APPLICATION NO.	FILING DATE	FIRST NAMED INVENTOR	ATTORNEY DOCKET NO.	CONFIRMATION NO.
10/624,649	07/23/2003	Robert R. Ricci	FS-00790	6899
7055	7590	03/13/2007	EXAMINER	
GREENBLUM & BERNSTEIN, P.L.C. 1950 ROLAND CLARKE PLACE RESTON, VA 20191			HESS, DOUGLAS A	
			ART UNIT	PAPER NUMBER
			3651	
SHORTENED STATUTORY PERIOD OF RESPONSE		NOTIFICATION DATE	DELIVERY MODE	
3 MONTHS		03/13/2007	ELECTRONIC

<b>Office Action Summary</b>	<b>Application No.</b>	<b>Applicant(s)</b>	
	10/624,649	RICCI ET AL.	
	<b>Examiner</b>	<b>Art Unit</b>	
	Douglas A. Hess	3651

## **DETAILED ACTION**

[54] ARTICLE TRANSFER DEVICE

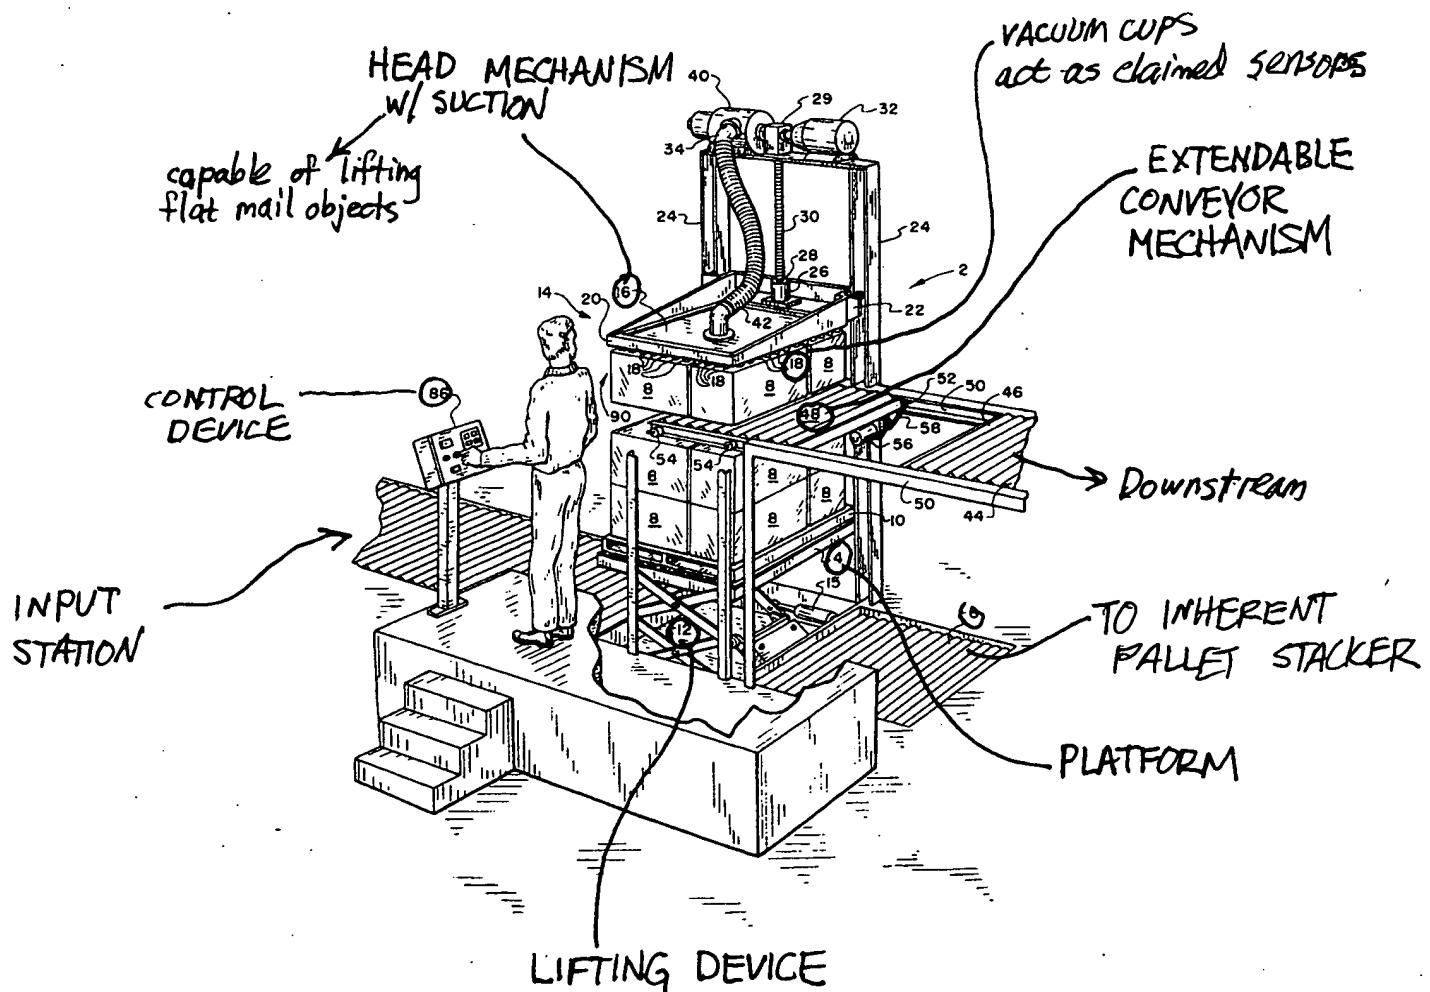
2. Claims 1-3, 8, 11-16 are rejected under 35 U.S.C. 102(b) as being anticipated by Jones (US Pat. No. 3,780,884).

See attached marked up cover sheet of Jones depicting the claimed features.
